J. CARTER BEAN
ARCHITECT

**Re: London Place**
London-Groveport Road & Summit Way
Grove City, Ohio 43213

This letter is to formally respond to the comments/recommendations provided by the Development Department.

# SITE DIMENSION PLAN

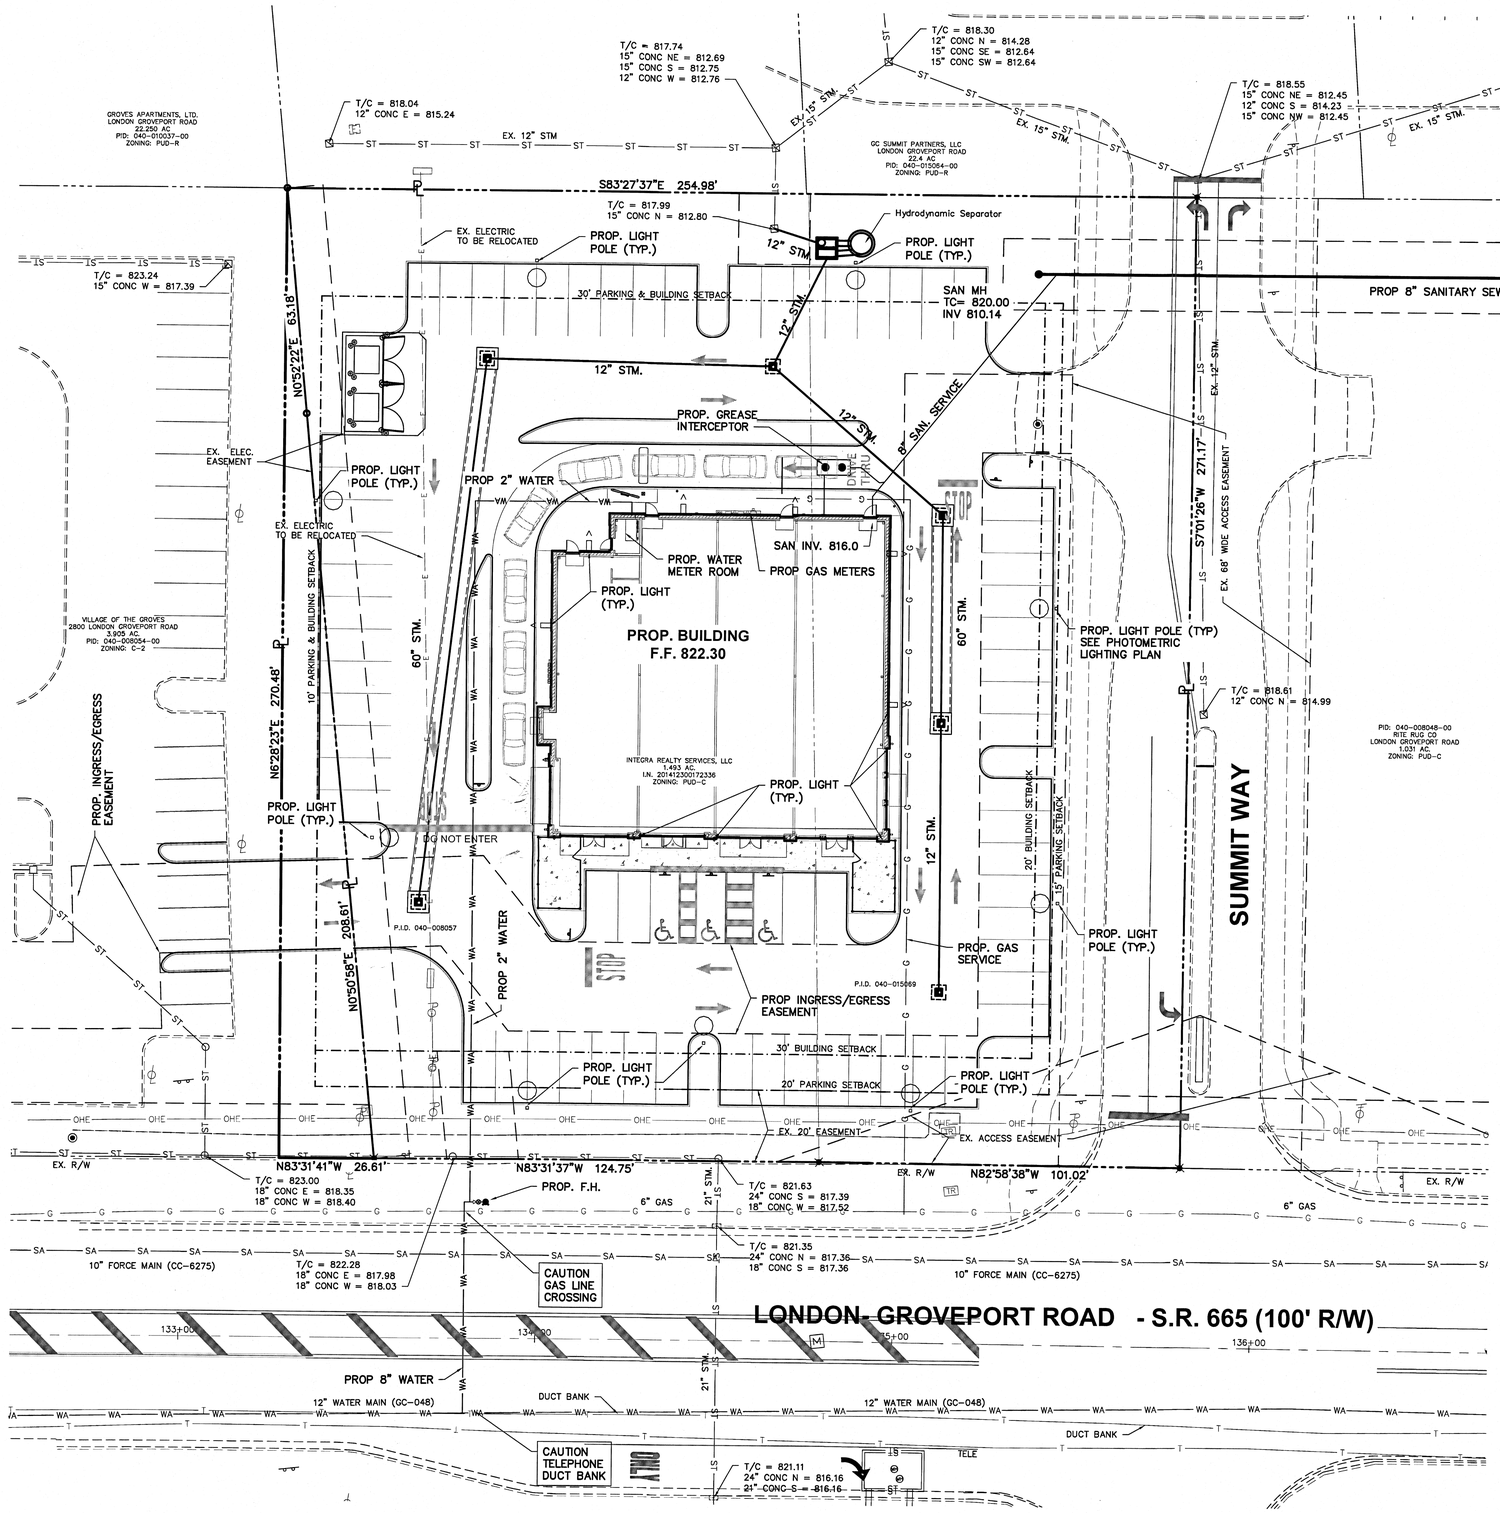
13. *Parking setback line differs on Sheet 2 of 5 and Sheet SD-1.1 for northern and southern portion of site.*

**Response:** **The current setback at the north side of the site is 30'. The current setback at the south side of the site is 20'. We are requesting a divergence from the code to allow for the pavement to encroach the setback lines. The north setback request is 20' and the south setback request is 15'.**

# SITE GRADING PLAN

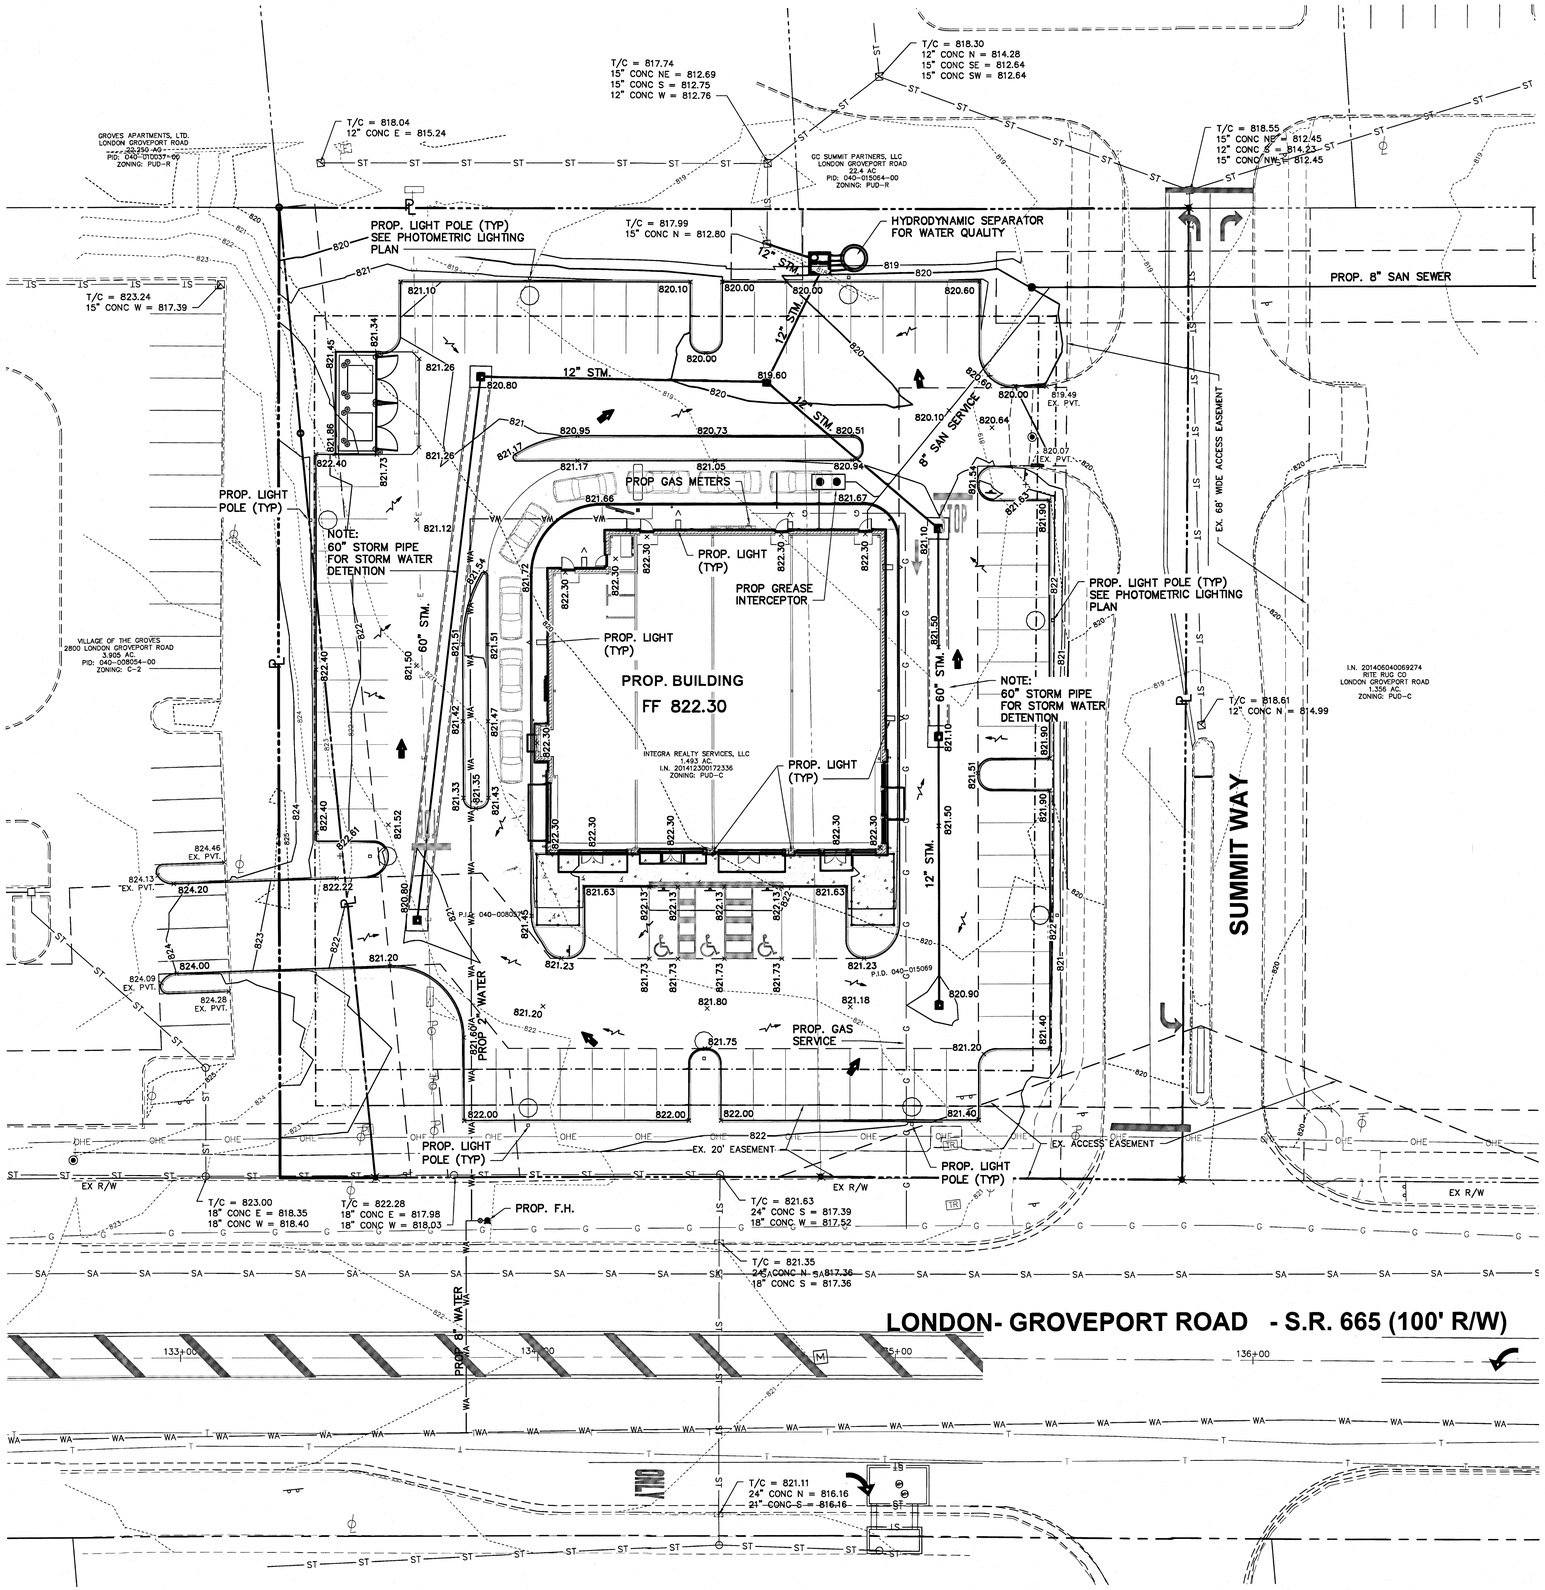
14. *Sheet 4 shows proposed 6 inch water main across London-Groveport Road connected to a fire hydrant. Grove City Planning and Zoning Code 1101.05 code requires 8 inch water main.*

**Response:** **The proposed water main is now shown as an 8 inch line.**

## INGRESS/ EGRESS EASEMENT EXHIBIT

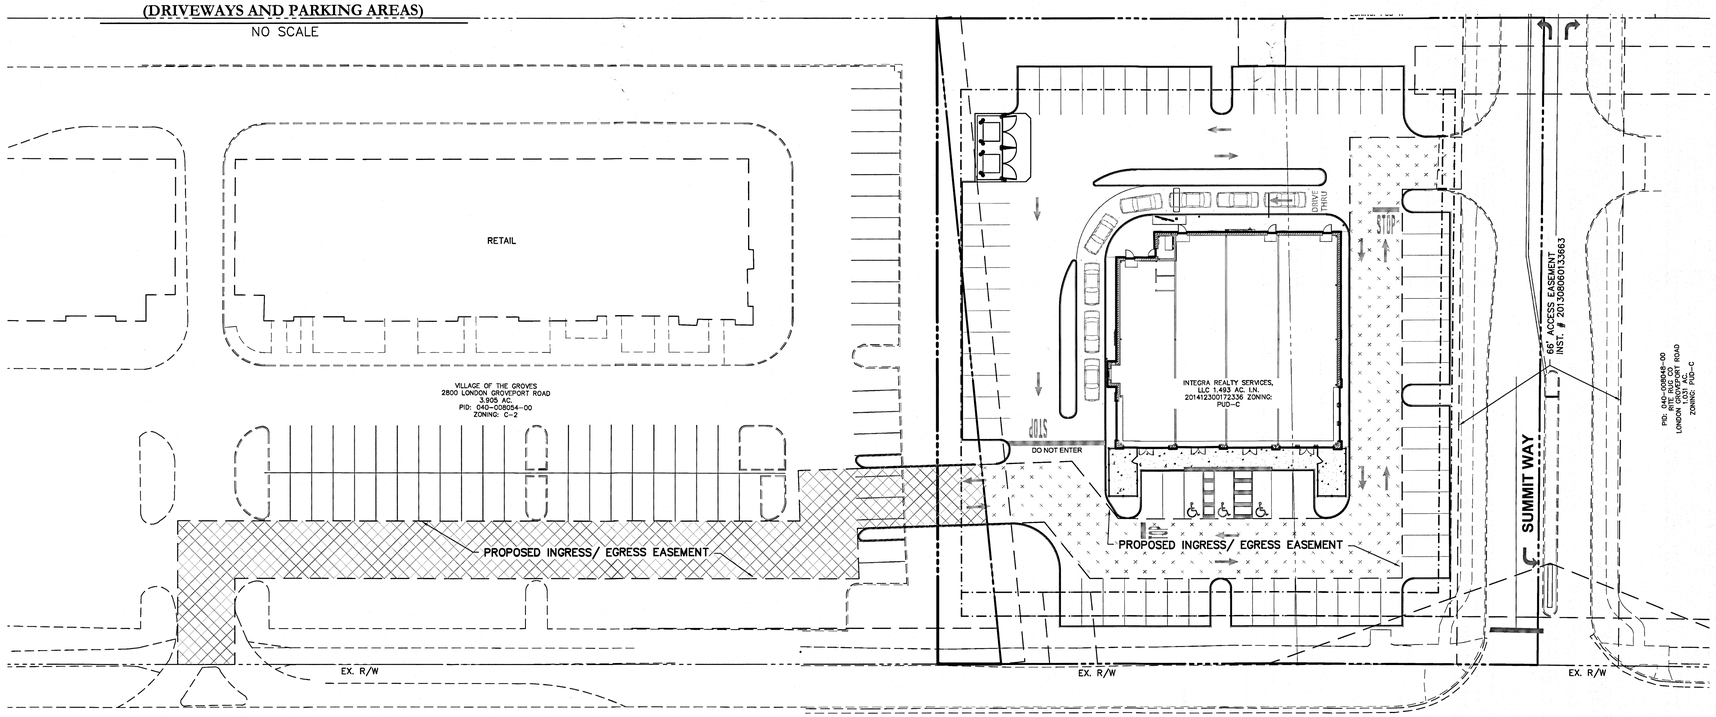
3. *The cross access easements shown on sheet 5/5 and supplemental exhibits will need to be recorded with the County.*
   **Response:** **The owner and developer will get this easement recorded with the County.**

## A WASTE ENCLOSURE PLAN

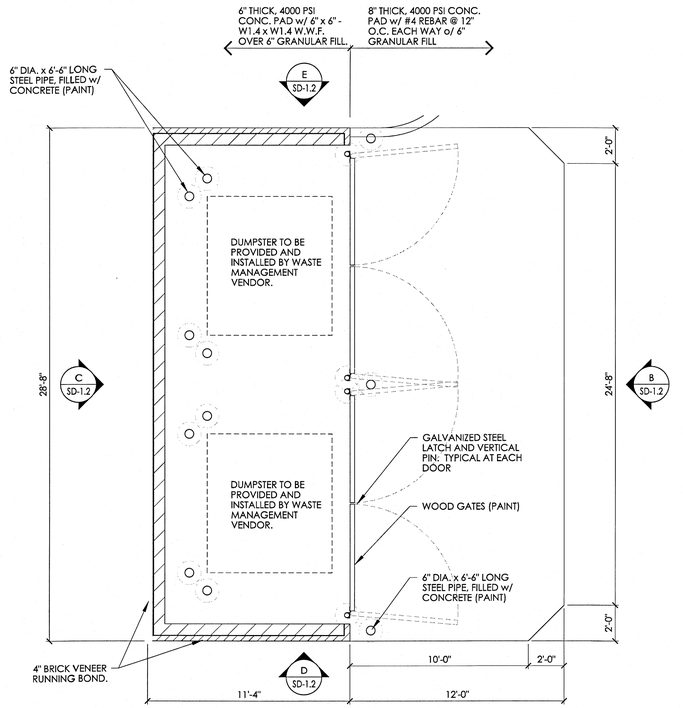
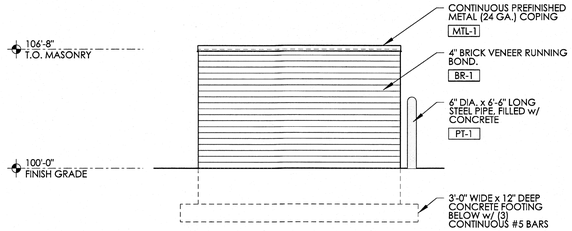
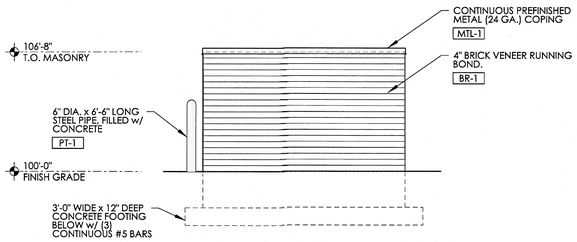
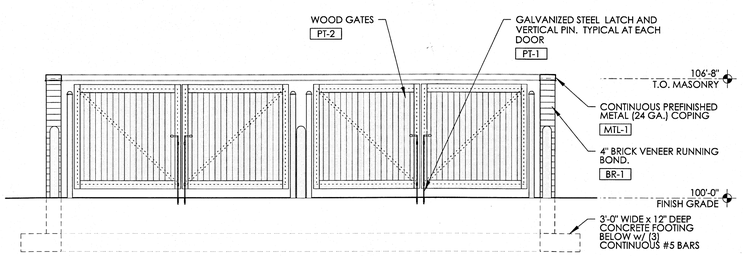
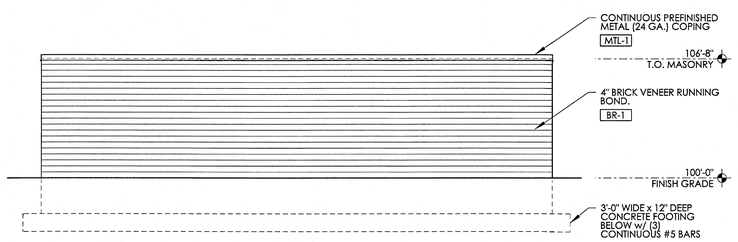
6. *1136.08: Landscaping around service structures: Trash Dumpster needs supplemental landscaping around it.*
   **Response:** **Large deciduous shrubs and perennial grasses have been added to supplement the proposed dumpster screen wall.**

A-2.1

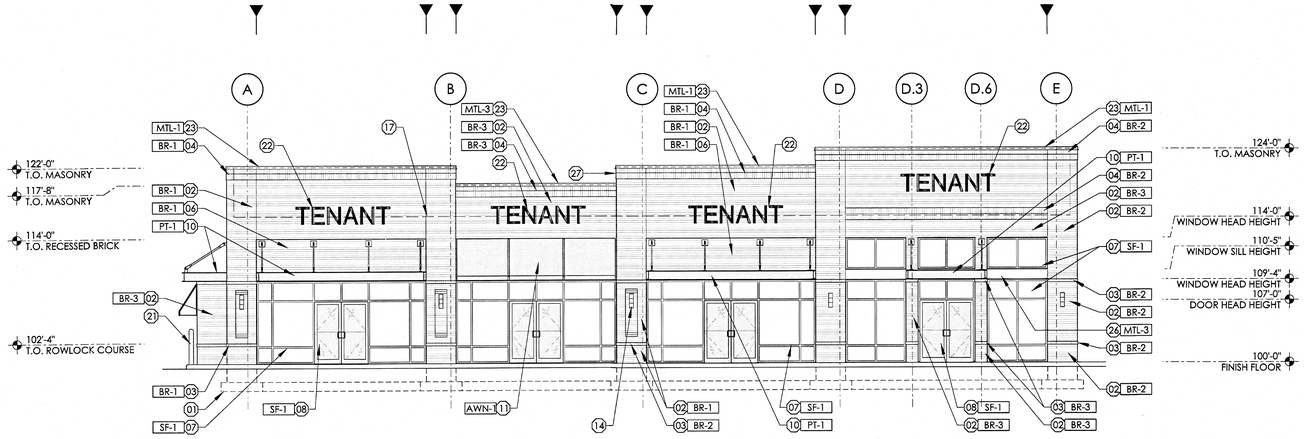
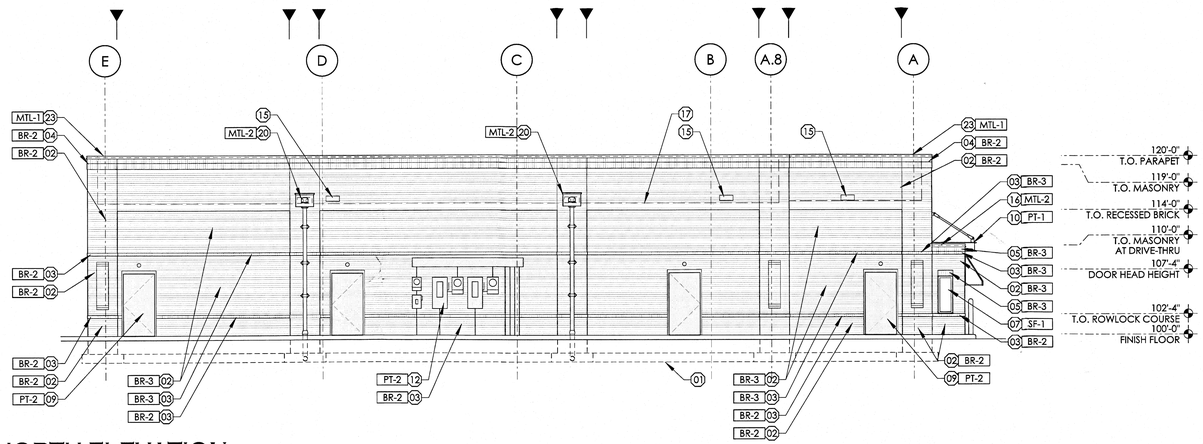
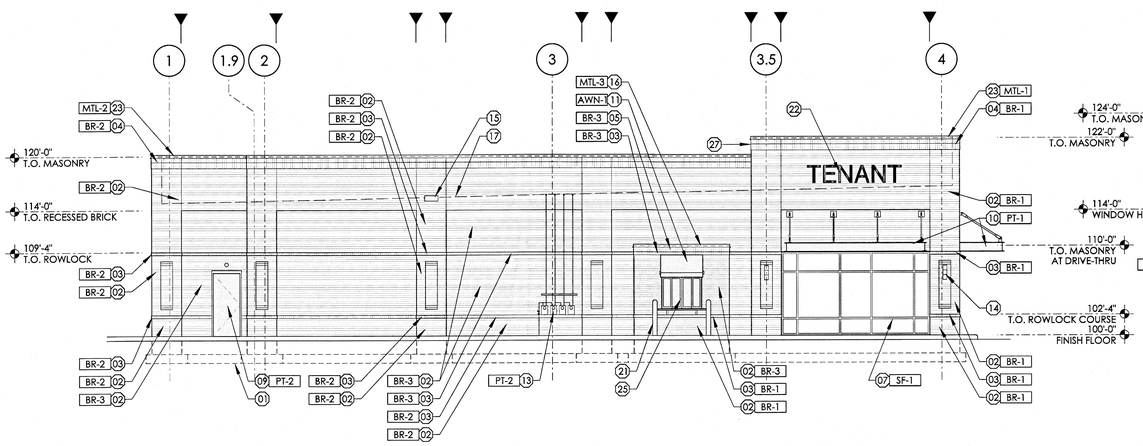
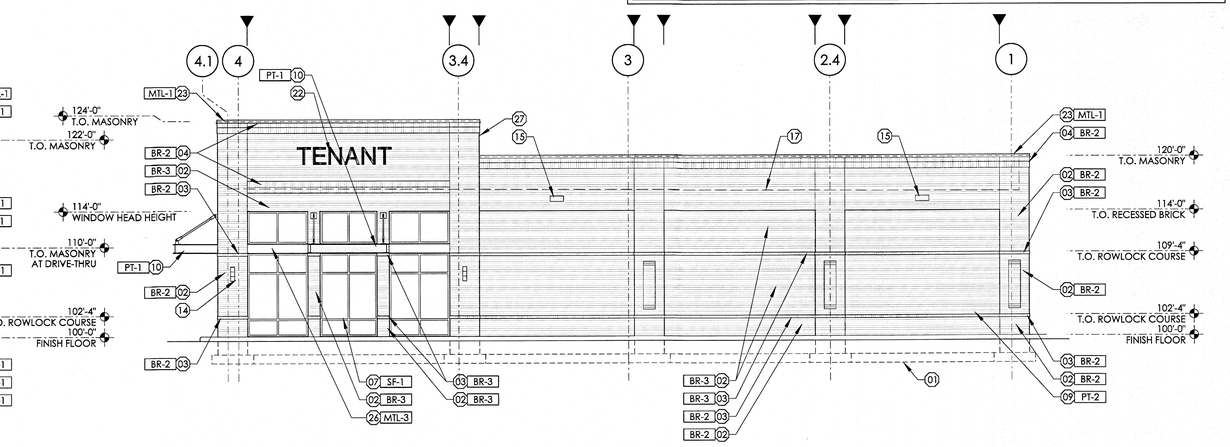
4. *An updated material list, material sample board, building elevations (sheet A-2.1), and color renderings will need to be submitted based on conversations regarding the revised building design to replace the previously proposed EIFS with brick.*
   **Response:** **An updated material list, material sample board, building elevations and color renderings have been included with this submission.**

SITE PHOTOMETRIC LIGHTING PLAN

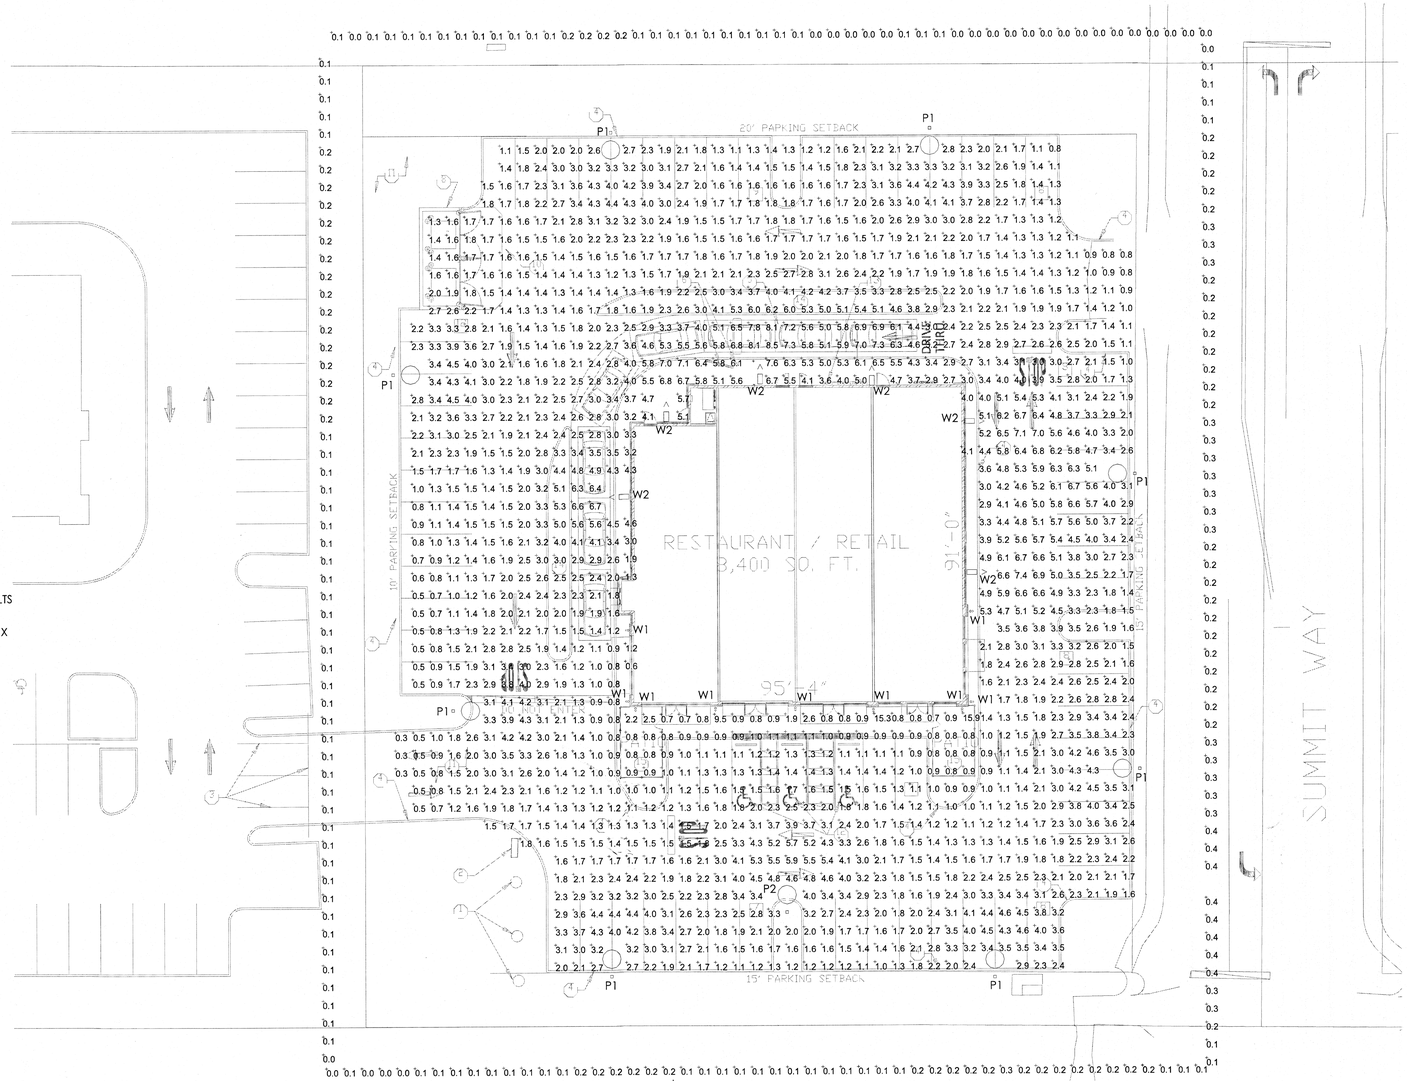
2. *The photometric plan shows multiple portions of the parking lot with lighting levels less than 0.5 footcandles. Fixtures should be relocated or outputs adjusted to ensure that the 0.5 footcandle minimum is met in all vehicular and pedestrian areas.*
   **Response:** **The photometric plan has been adjusted.**
